ADDENDUM NO. 2 TO CONTRACT DOCUMENTS

Project: Hyattown Pumping Station
Hazen and Sawyer Project No. 30961-010

DATE: April 5, 2016

Owner: DAVIDSON WATER, INC.

ADDENDUM NO. 2	DATE 4-5-16	DAVIDSON COUTY NORTH CAROLINA	H & S JOB NUMBER 30961-010	REFER TO CONTRACT DRAWING NUMBER C10
ATTACHMENT NO. 4	BY MJB	DAVIDSON WATER INC. HYATTOWN PUMP STATION IMPROVEMENTS	CONTRACT NUMBER -	SHEET 1 OF 1

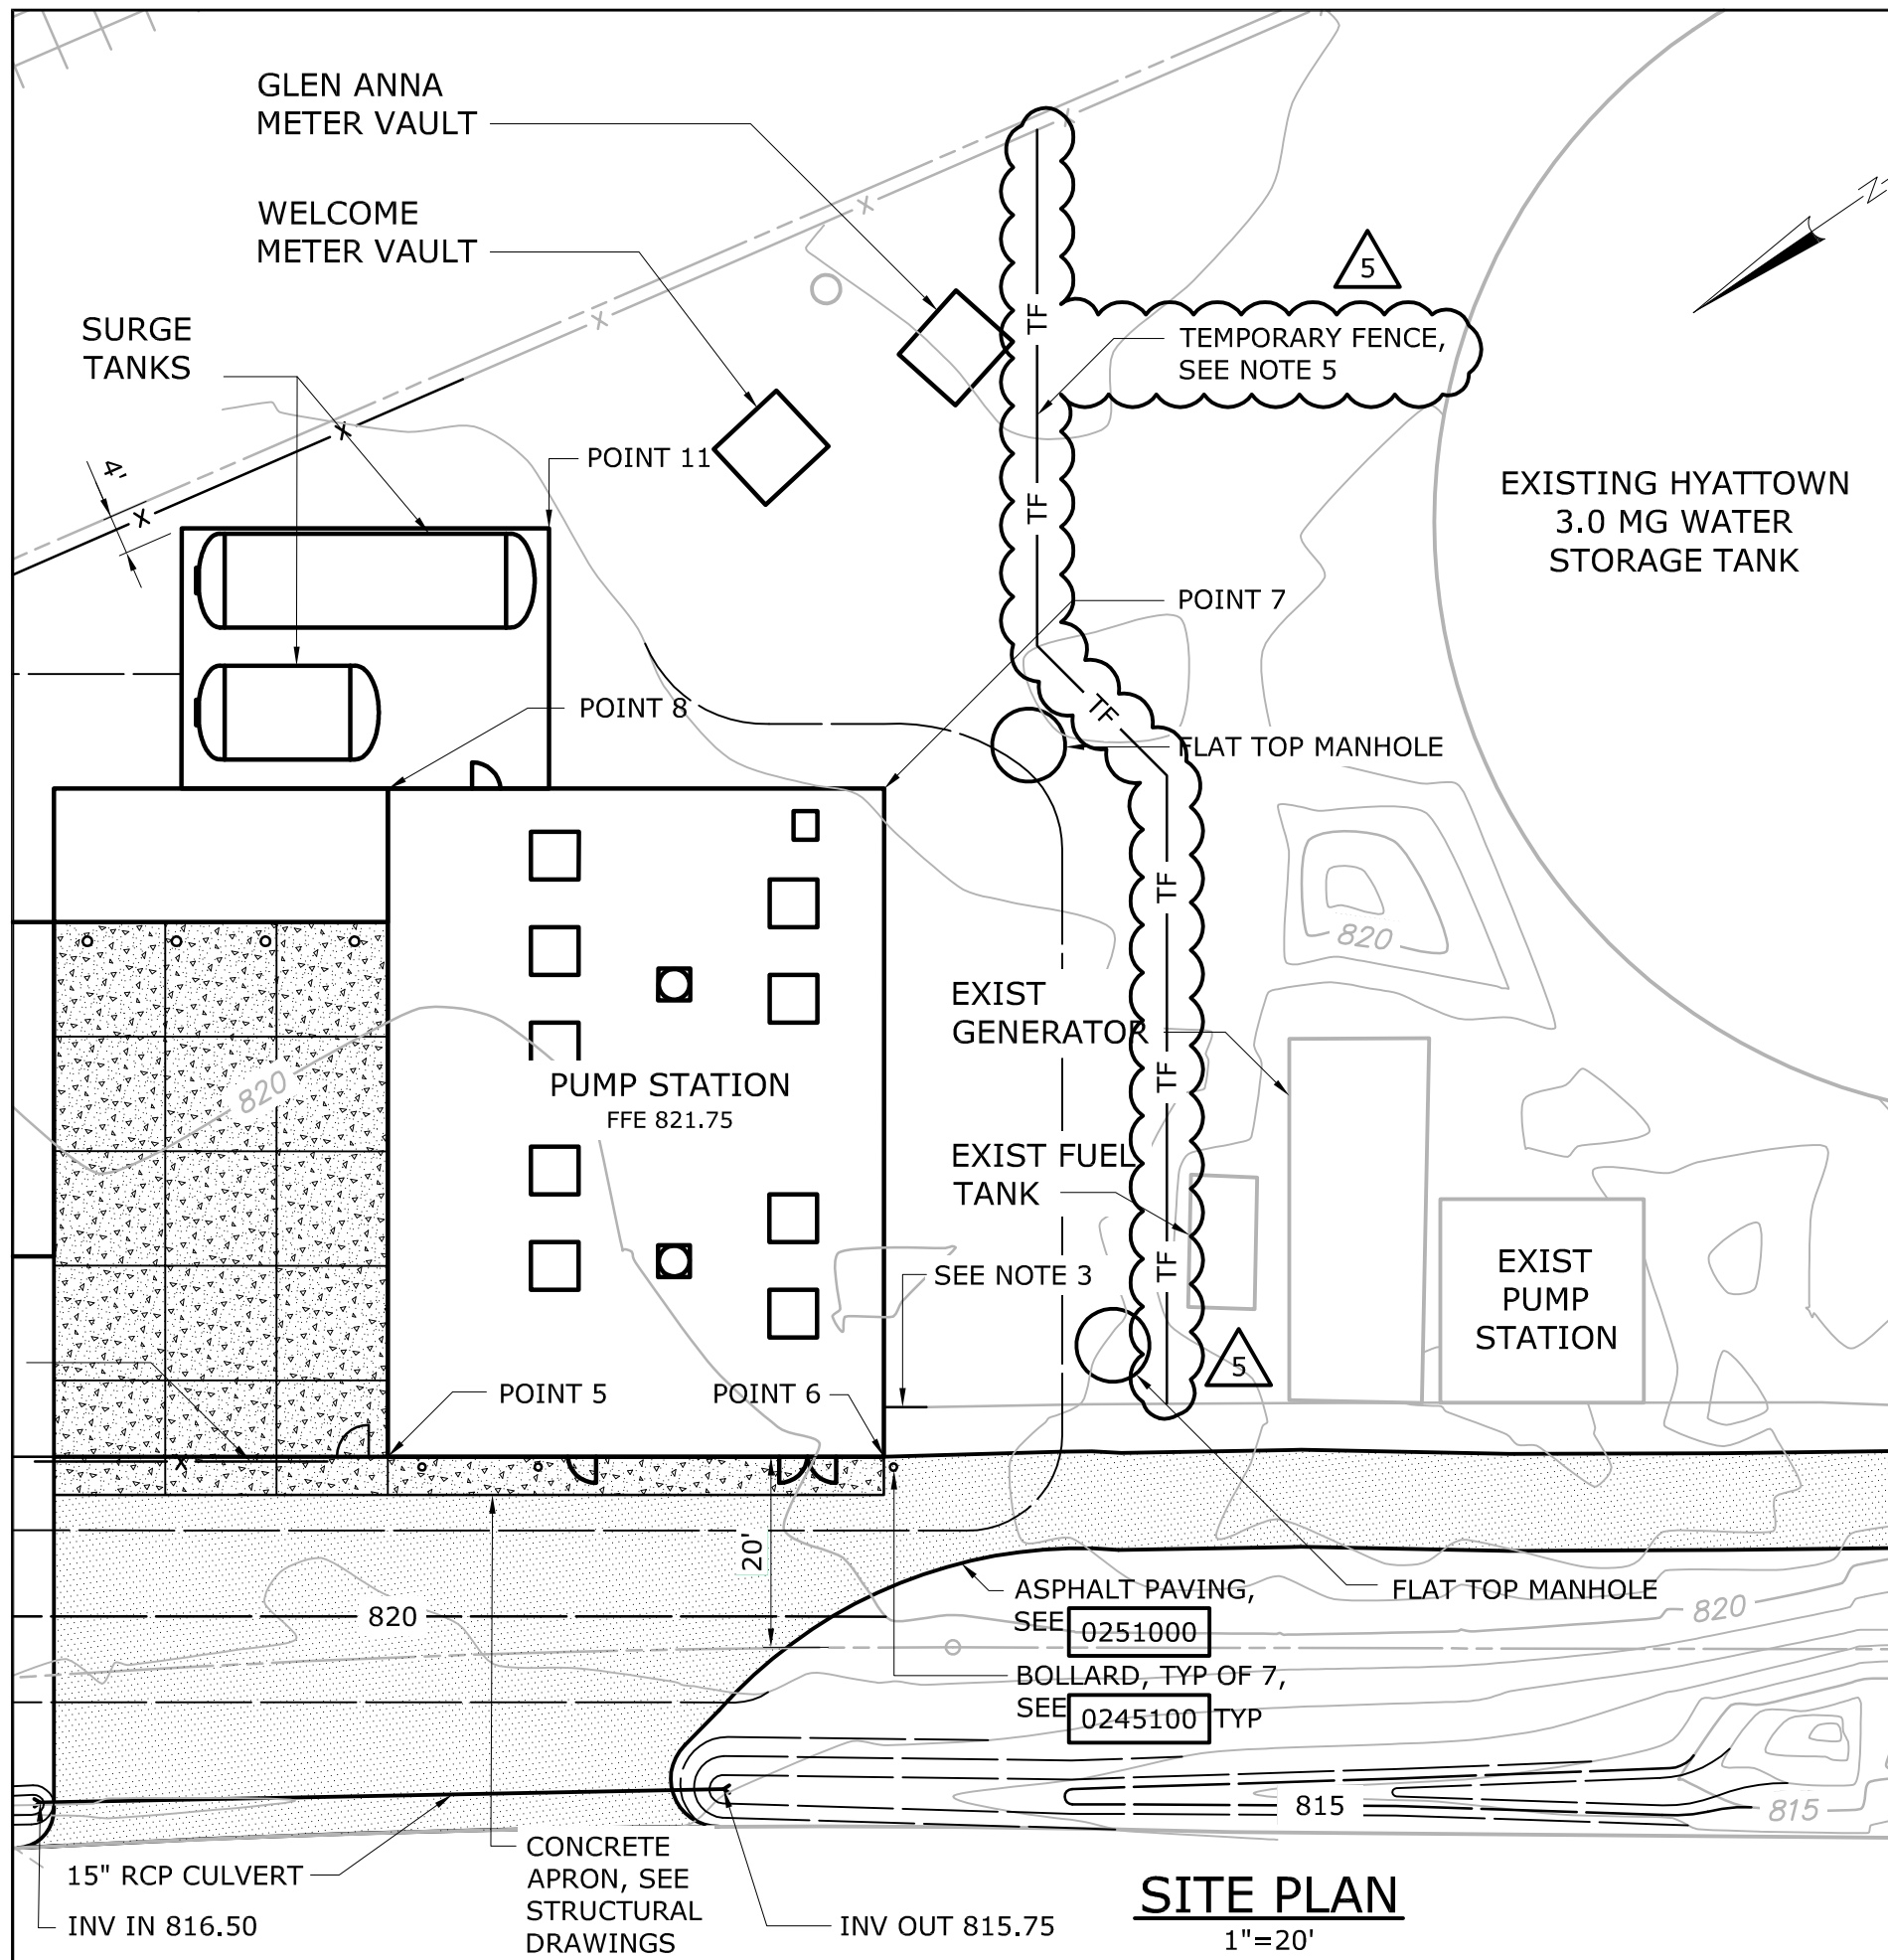
Drawing C10

Add existing waterline diameters and elevations as shown in the sketch attached to this Addendum as Attachment 4.

ADDENDUM NO. 2	DATE 4-5-16	DAVIDSON COUTY NORTH CAROLINA	H & S JOB NUMBER 30961-010	REFER TO CONTRACT DRAWING NUMBER C12
ATTACHMENT NO. 5	BY MJB	DAVIDSON WATER INC. HYATTOWN PUMP STATION IMPROVEMENTS	CONTRACT NUMBER —	SHEET 1 OF 1

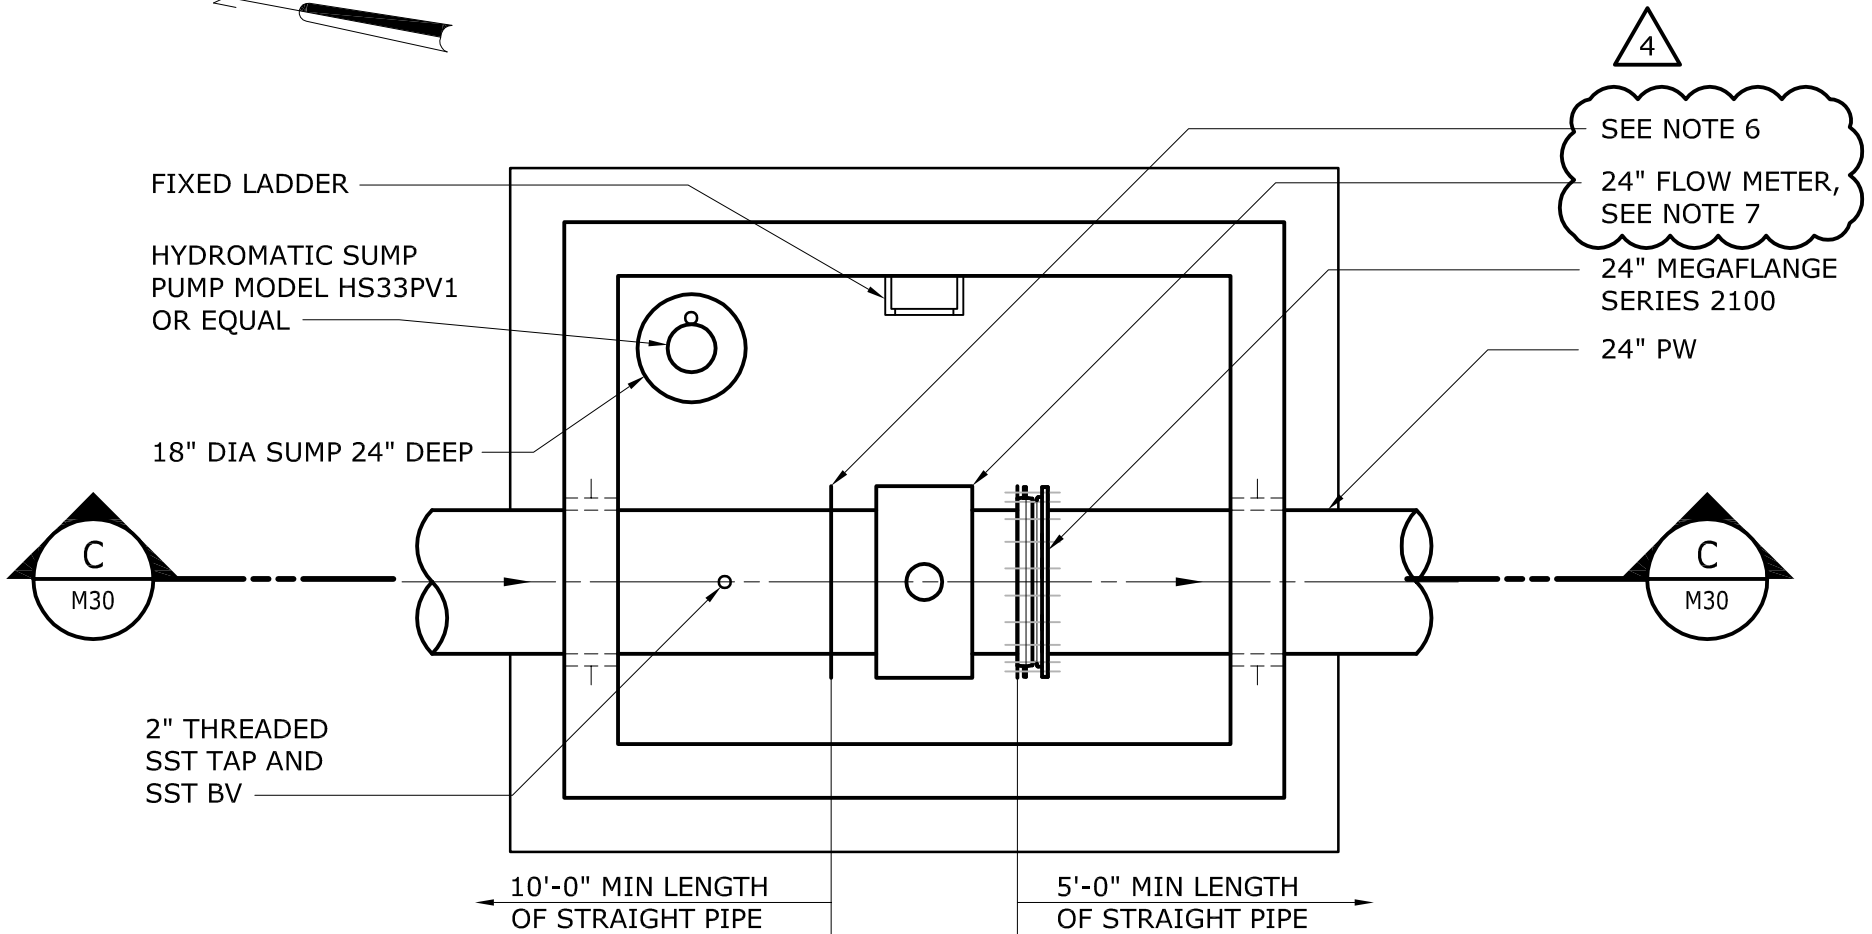
Drawing C12

Add temporary steel fencing and Note 5 as shown in the sketch attached to this Addendum as Attachment 5.

5. PROVIDE TEMPORARY STEEL FENCING TO SECURE EXISTING OPERATIONS DURING CONSTRUCTION. RELOCATE TEMPORARY FENCING AS REQUIRED BY CONSTRUCTION ACTIVITY. PROVIDE 20 FT GATE IN TEMPORARY FENCING AND COORDINATE LOCATION WITH OWNER. HEIGHT OF TEMPORARY FENCE TO MATCH EXISTING FENCE.

DATE:	APRIL 2016
HAZEN NO.:	30961-010
CONTRACT NO.:	1
DRAWING NUMBER:	E20

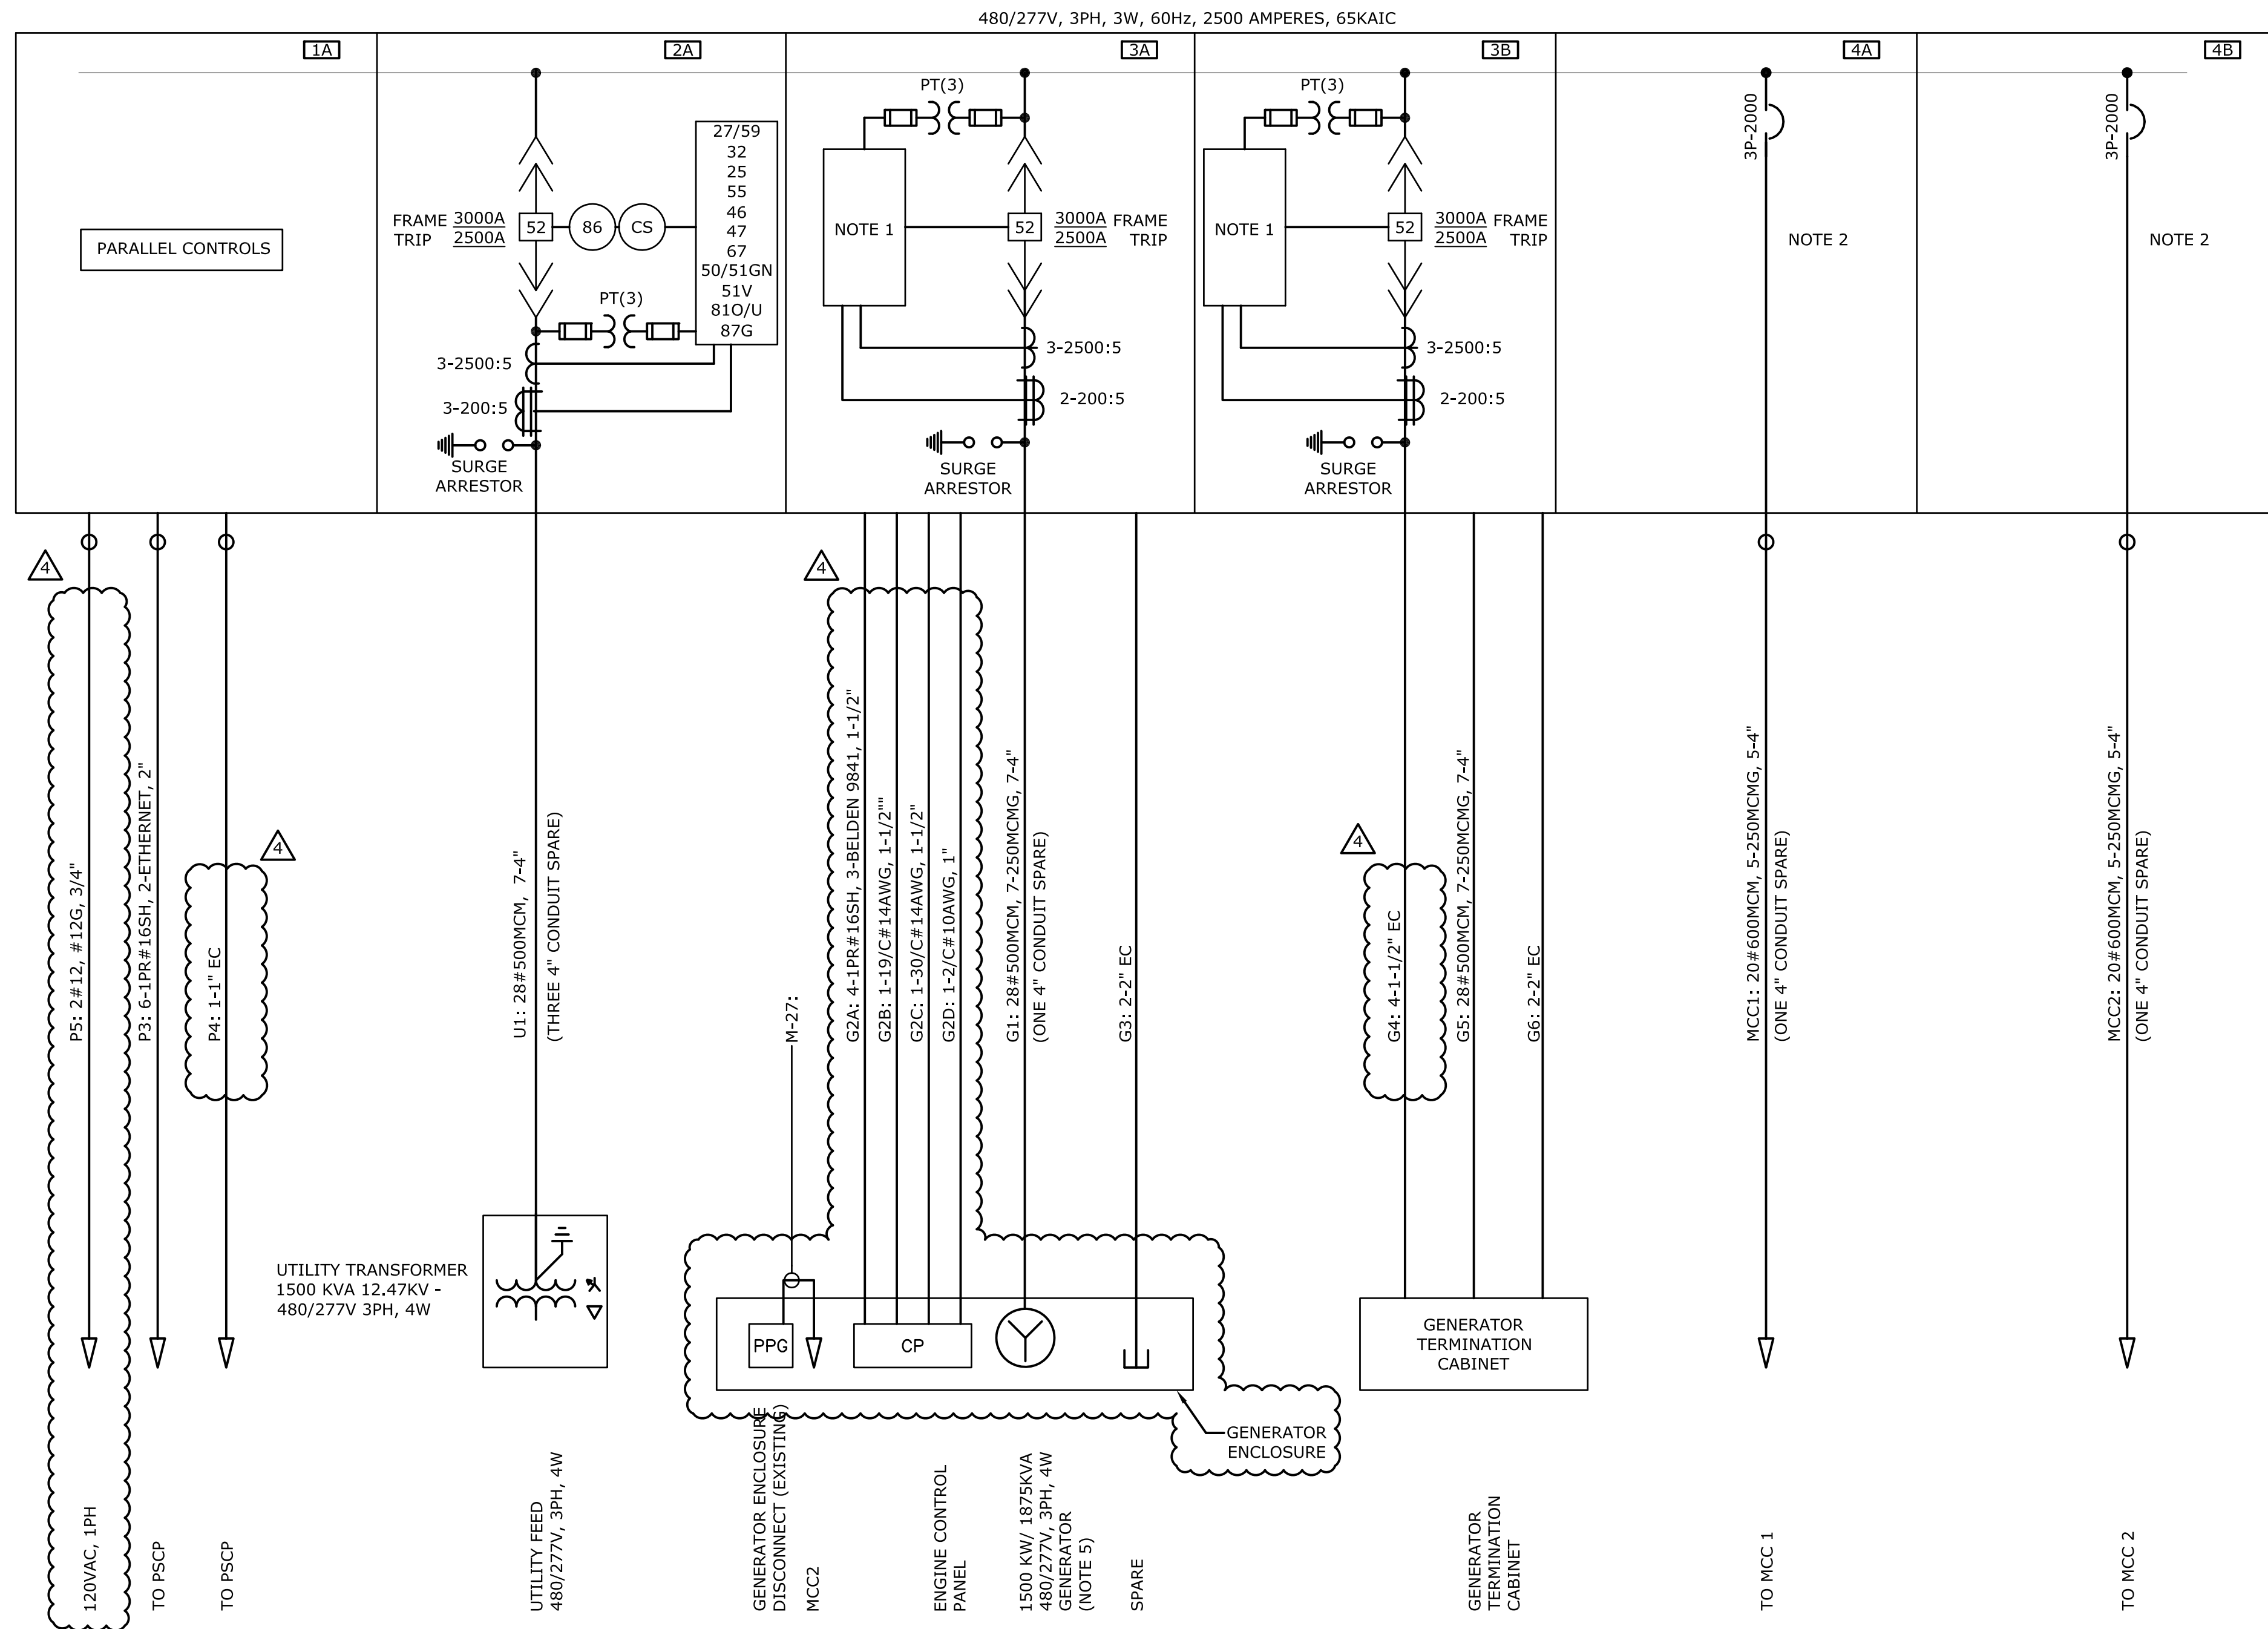
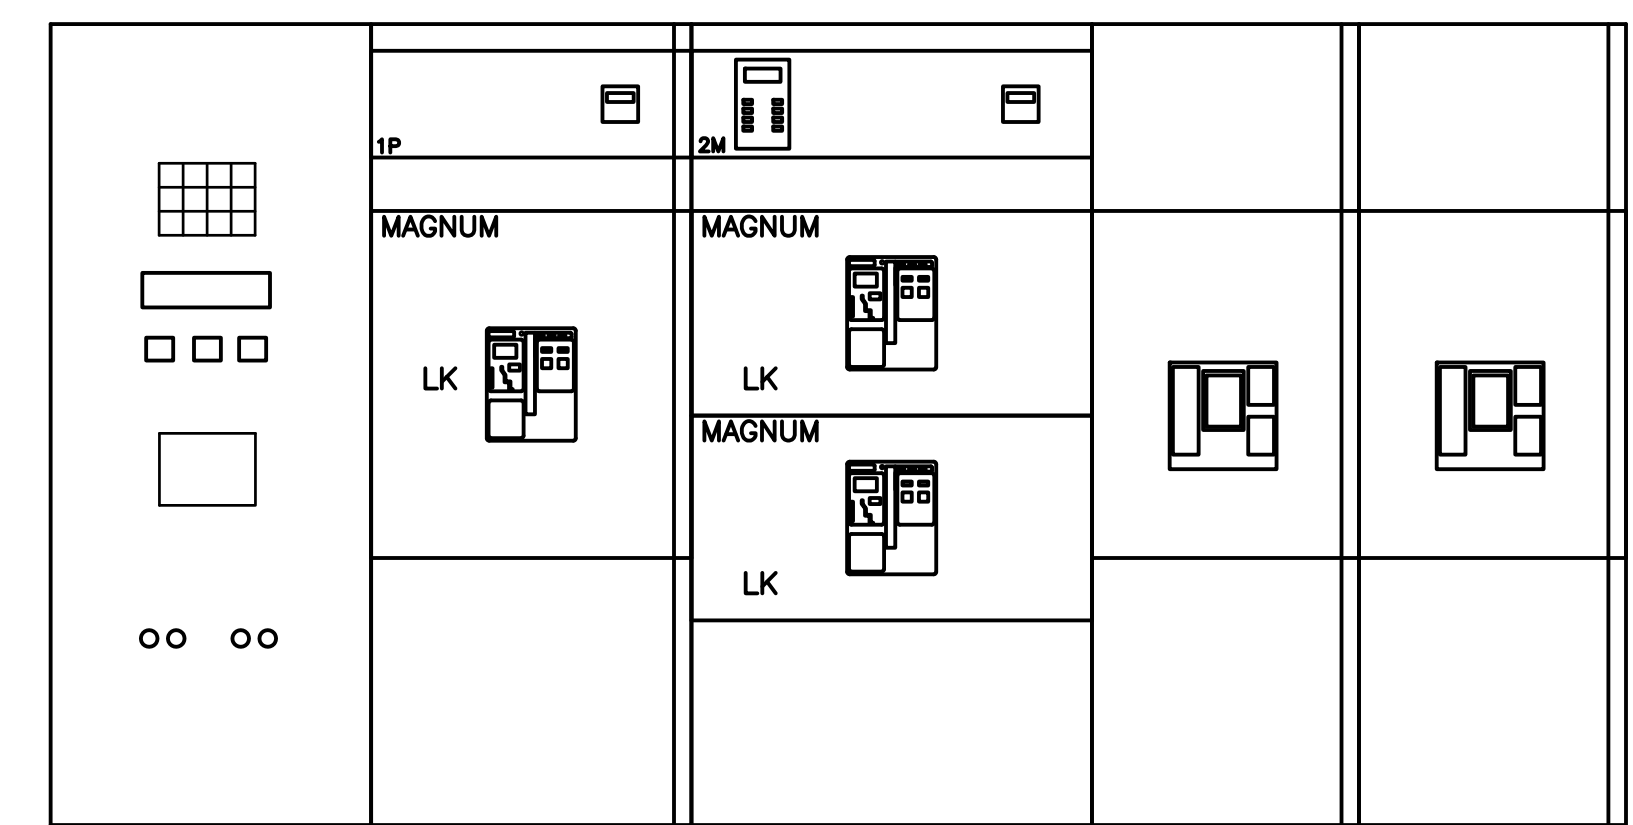
Drawing E20

Replace Drawing E20 with the revised Drawing E20 attached to this Addendum as Attachment 8.

Drawing E20

In Note 5, **replace** the first sentence with:

“The Owner shall furnish, install, fuel, test, and start up generator.”
